MEMORANDUM

To: Montgomery Township Planning Board

Re: **The Malvern School Properties, LP**
Preliminary and Final Major Site Plan Review 2
982 Georgetown-Franklin Turnpike (County Route 518)
Block 28010, Lots 57 & 58
H-C Highway Commercial Zone

Date: November 30, 2023

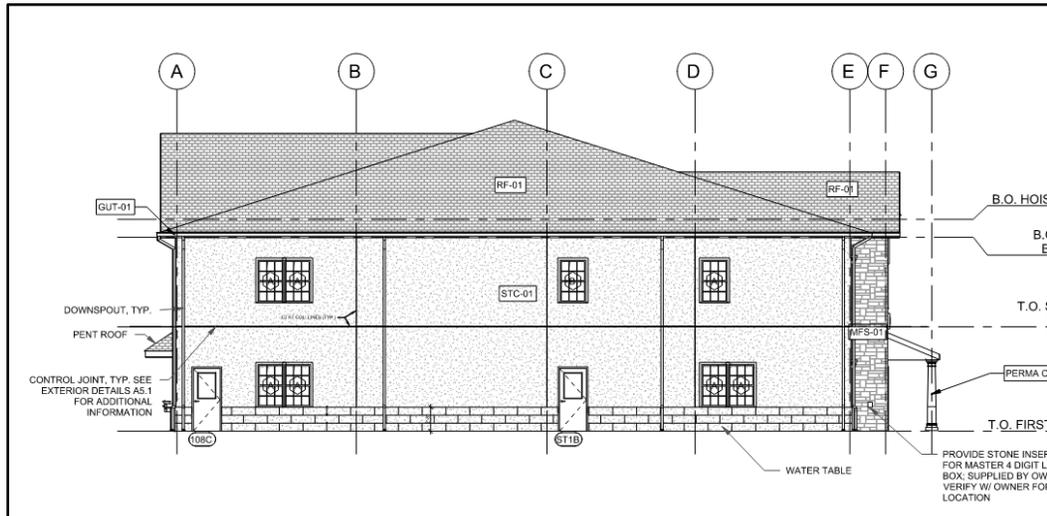
11.3. Description of Proposed Childcare Facility: As indicated in the preceding image, the overall building design contains a pseudo-traditional colonial style. The building contains a hipped-pyramid roof, six over six detailed paned windows, a faux brick façade at the base and center of building, and double doors beneath a decorative entryway. The entranceway contains a more elaborate, arched window, and a triangular pediment. Columns support the overhang which resides over the front double doors.

- 11.4. Building Exteriors:** The plan complies. §16-4.12e.1(a) requires that building exteriors in the HC District including any accessory buildings, shall be architecturally compatible and shall be constructed of complementary materials. This does not apply as there is only one building proposed on site (the accessory structures are not buildings).

- 11.5. Pedestrian Scale:** §16-4.12e.1(b) requires that architectural details, style, color, proportion and massing shall create a pedestrian scale development. The front entrance of the childcare facility front entrance is of a pedestrian scale, as are the heights of the habitable stories of the building. The size and proportions of the windows and the doors are at a pedestrian scale. The canopy overhang is pedestrian friendly as it provides protection from the elements.

- 11.6. Building Entrances:** The plan complies. §16-4.12e.4(a) requires that all entrances to a building shall be articulated utilizing architectural elements such as lintels, pediments, pilasters, columns, porticoes, porches, or overhangs. Such elements shall be architecturally compatible with the overall building. As indicated in 10.3, the design of the childcare facility does comply. As indicated in 10.3, the design of the childcare facility does comply.

- 11.7. **Visual Breaks: Variance relief is required.** §16-4.12e.5(a) requires that building exteriors shall have vertical and/or horizontal offsets to create visual breaks along each facade. Long, monotonous, uninterrupted walls are not permitted. The front and rear façade of the childcare building contain visual breaks, the sides, as indicated in the preceding image, do not. **Variance relief is required.**
